STAFF RECOMMENDATION
1505 Holly Street
November 18, 2015

Application: New construction—addition
District: Lockeland Springs-East End Neighborhood Conservation Zoning Overlay
Council District: 06
Map and Parcel Number: 08309045300
Applicant: Craig Kennedy
Project Lead: Melissa Baldock, melissa.baldock@nashville.gov

Description of Project: Application is to add a front porch and a side entry roof to a non-contributing duplex structure.

Figure 1. 1505 Holly Street

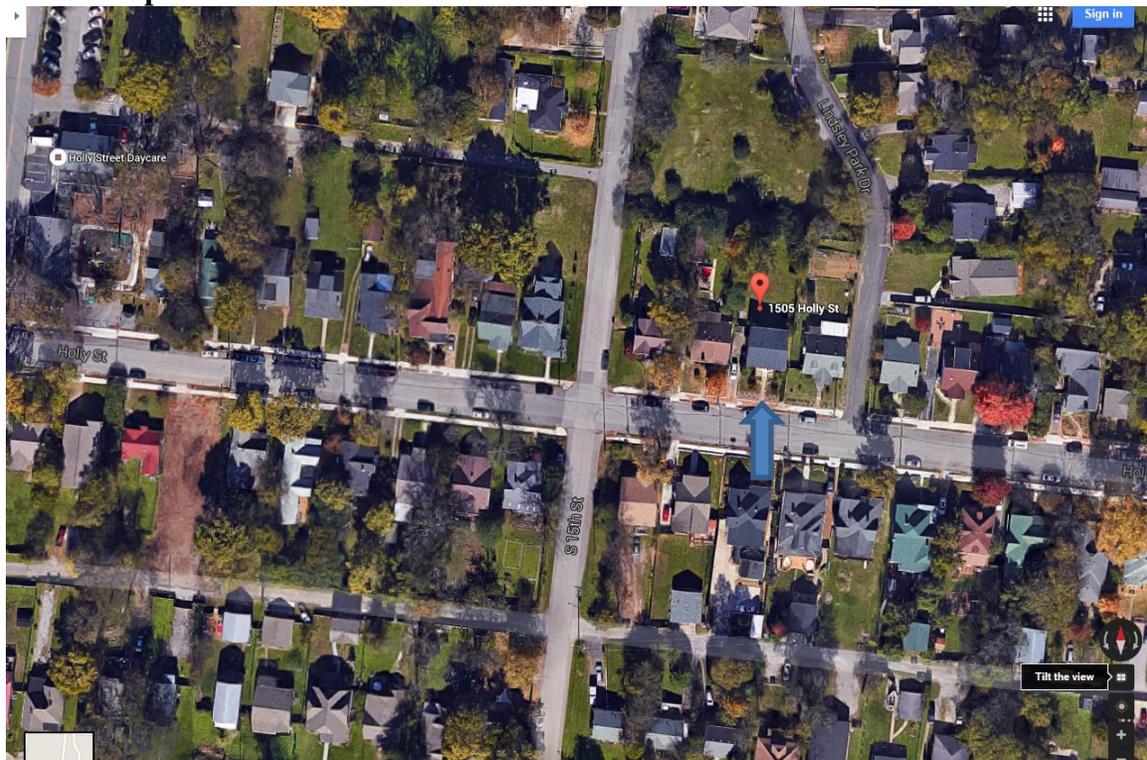
Background: 1505 Holly Street is a duplex constructed c. 1980 (Figure 1). It is considered to be non-contributing.

Figure 2 shows the location of the proposed side entry roof

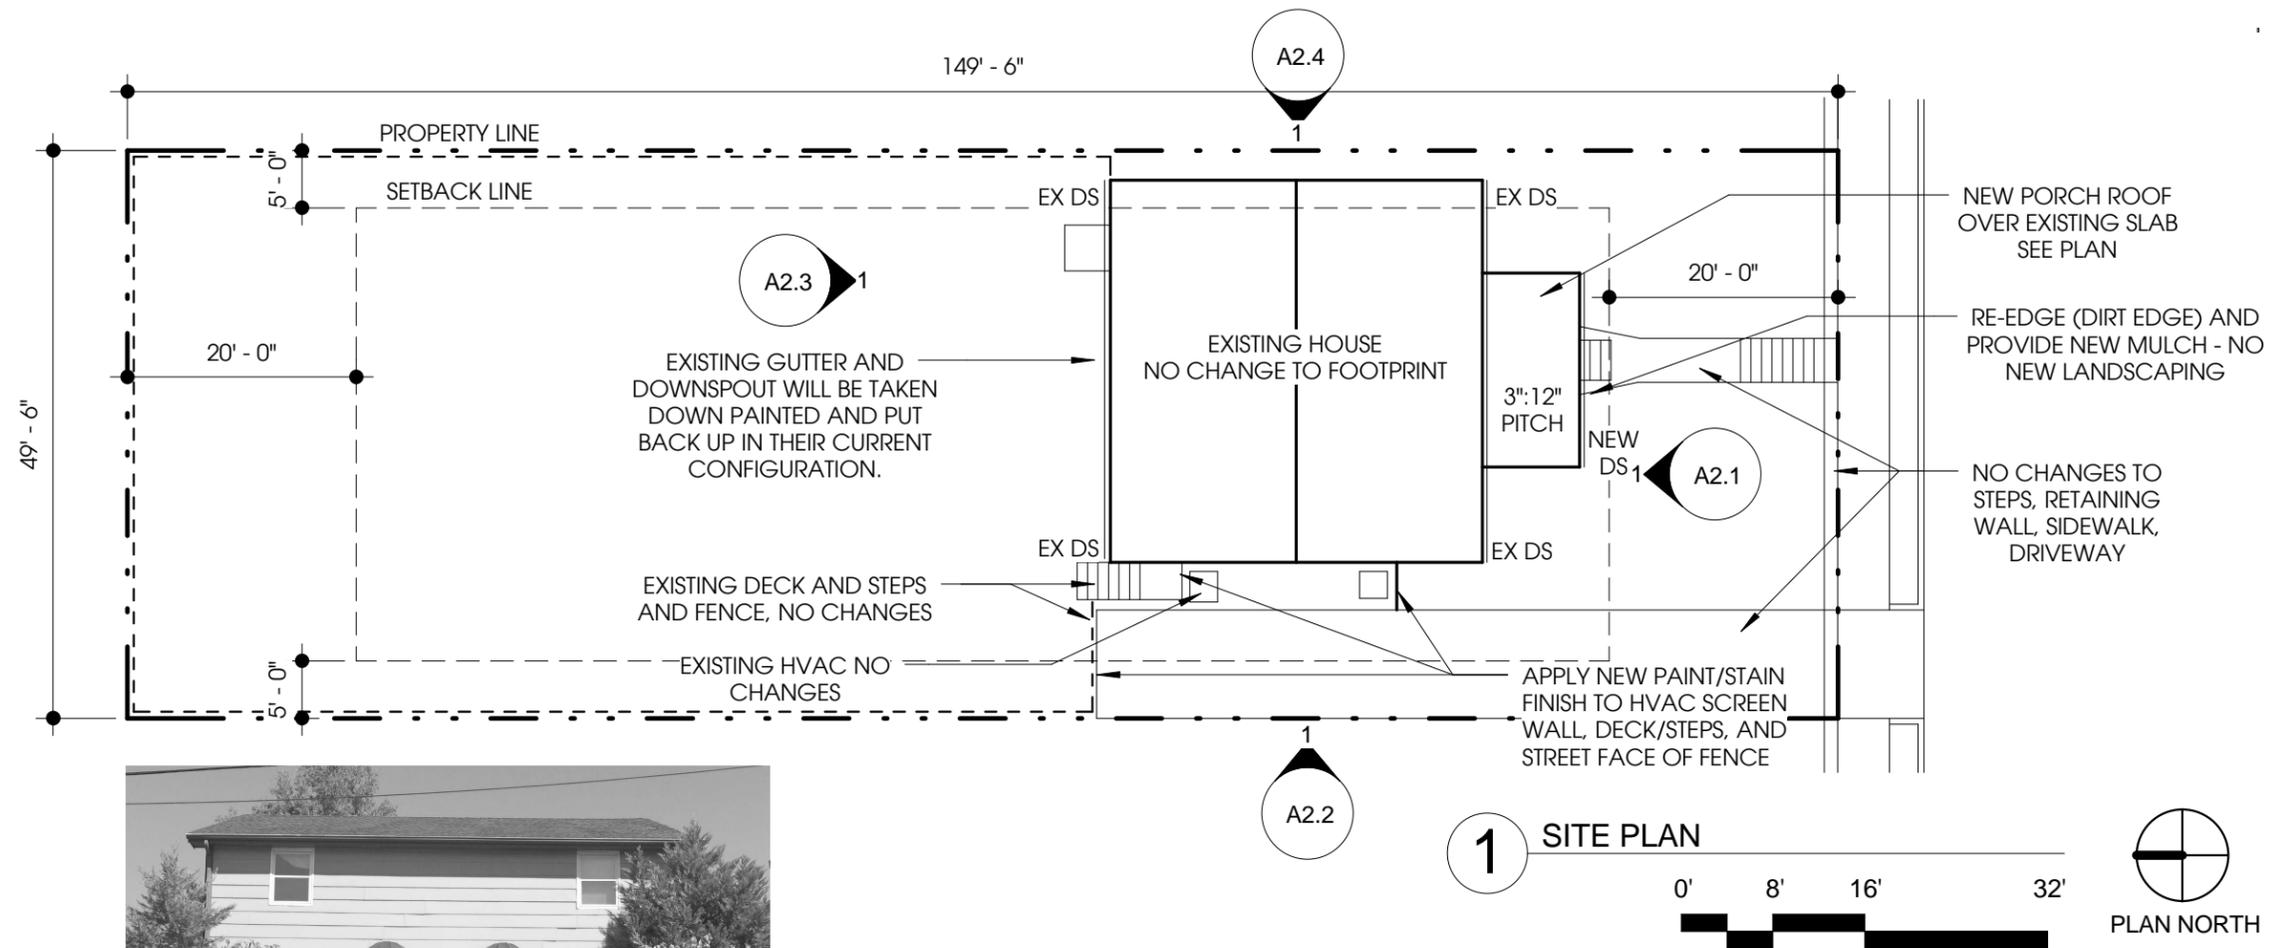
On the left façade, the applicant proposes to construct a shed roof over an existing side entry (Figure 2). The roof will be eight feet (8') wide and will be located about ten feet (10') above the entry platform.

1 SOUTH ELEVATION

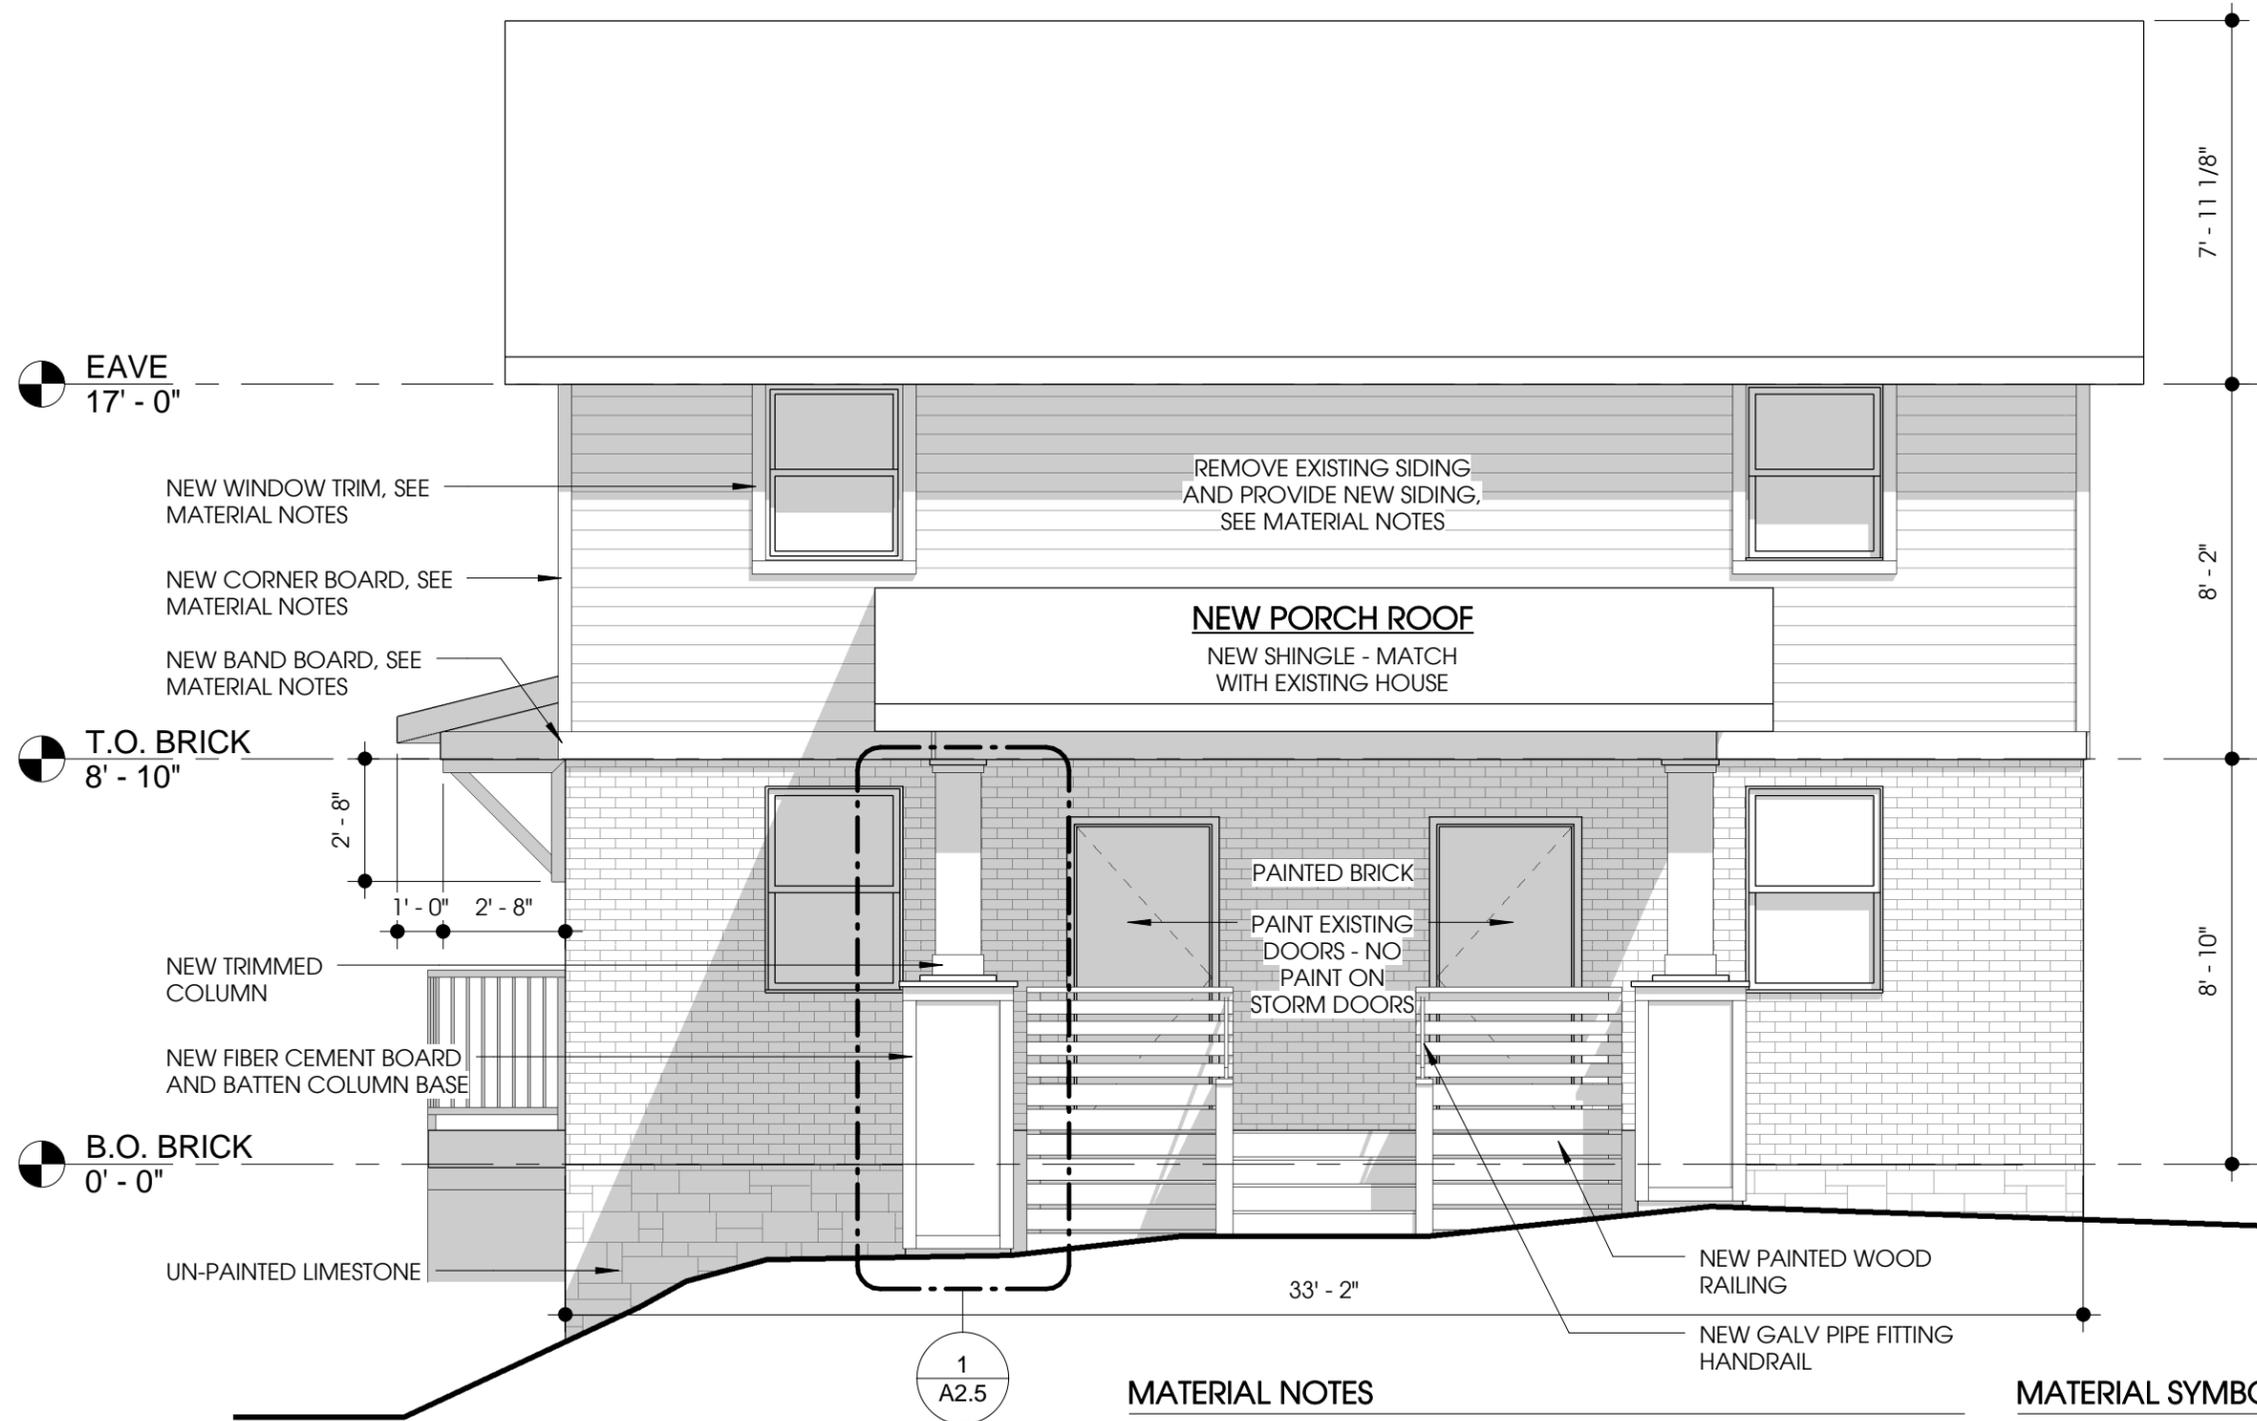
Design: The design of the porch addition is appropriately scaled to the existing structure and adds an architectural element that is typical for historic structures in the immediate vicinity. Staff notes that the front porch railings do not extend all the way to the house wall and to the porch columns, leaving a gap of approximately three inches (3"). Staff recommends that the railings either touch or extend further over to the columns and house wall. With the condition that the railings extend further over to the house wall and columns, staff finds that the addition meets Section II.B.10. of the design guidelines.

The porch materials include fiber cement columns and fiber cement board and batten bases. Staff recommends that the bases be a masonry material like stone, brick, or stucco, as column bases that extend to the ground were historically masonry. Staff also recommends approval of the masonry sample prior to purchase and installation. Wood or cement fiberboard columns typically stop at the porch floor and do not extend in front of the porch to the ground. Although the building itself is not historic, alterations should be appropriate for the overall district. The porch roof will be asphalt shingles in a color to match that of the existing house. Board and batten will be used to clad the gable fields of the porch roof, and fiber cement trim will be used for the porch rack and soffit. The porch will include a painted wood railing with galvanized pipe hand rail.

1. The column bases be a masonry material, and staff approve the masonry color, dimensions and texture; and
2. The porch railings extend further towards the house wall and the column bases.
